Technical Bulletin N®

REFERENCE	BT_2010_FR20_08_UK
DATE	2010 April 8th
SUBJECT	Several mandatory updates
PART	Steering arm, front rocker, GB actuator, extractable seat, crankshaft loom, radiator net, ECU

2. New front rocker

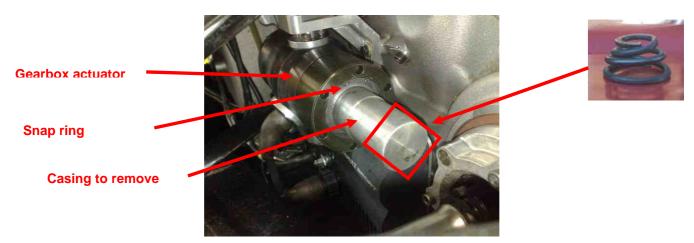
The new front rockers are now available from your Renault Sport spare parts dealer. The parts are already assembled with a new and stronger rocker axle. The reliability of both parts has been improved: stronger material and improved shape

These parts are now the only ones allowed. You must return the old rockers to Renault Sport.

5. New ECU mapping

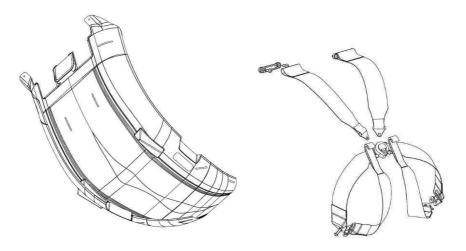
Note: the barrel potentiometer setup has to be modified to use correctly the new mapping. It is really important to set it accurately because all the gearshift system depends directly on this sensor. The easy way to set it is to put the car in 3rd gear, and to set the barrel potentiometer value to 2.50V.

The barrel voltage values have been rectified in the new mapping, and please find hereafter the correct new values:

Gear	Reverse	Neutral	1st	2 nd	3 rd	4 th	5 th	6 th	7 th
Reading (V)	0.386	0.915	1.440	1.965	2.500	3.040	3.565	4.090	4.625

6. Fitting of the extractable seat

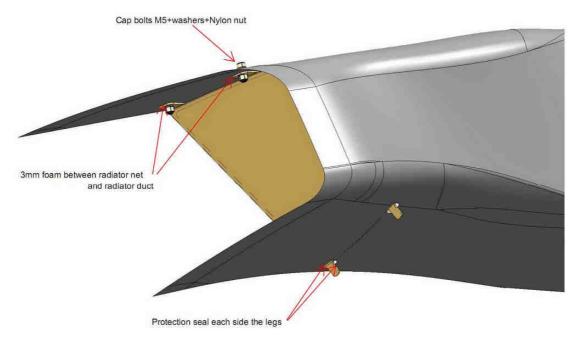
- Make sure that the seat is correctly fitted in the carbon shell
- Make sure that the holes for the leg straps in the carbon shell and in the seat are in front of each others.
- Make sure that the leg straps are exiting in front of the driver's crotch
- Make sure that, the driver does not sit on the leg straps when he is sitting in the car
- The driver seat must not exceed the carbon shell length and width.
- Make sure that the straps are always visible and easily usable when the driver is in the car, as shown below:

• Make sure that the middle blue and red straps can be easily extended: (ie make loops and fit them using bodywork tape to the extractable seat)

7. Fitting of the radiator nets

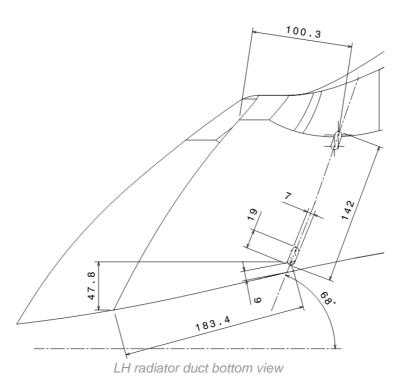
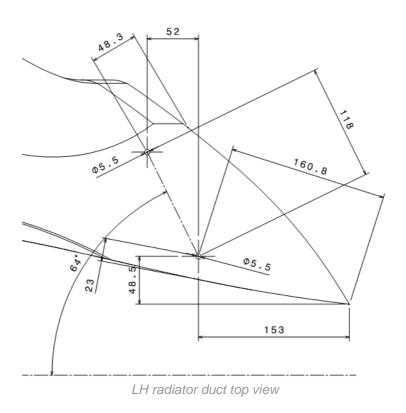
The original radiator nets are now available from your Renault Sport spare parts dealer:

To fit the nets, you will have to respect the following quotations. These quotations are only given to help you fitting them, but must be respected as much as possible:

These new parts are now the only nets allowed.
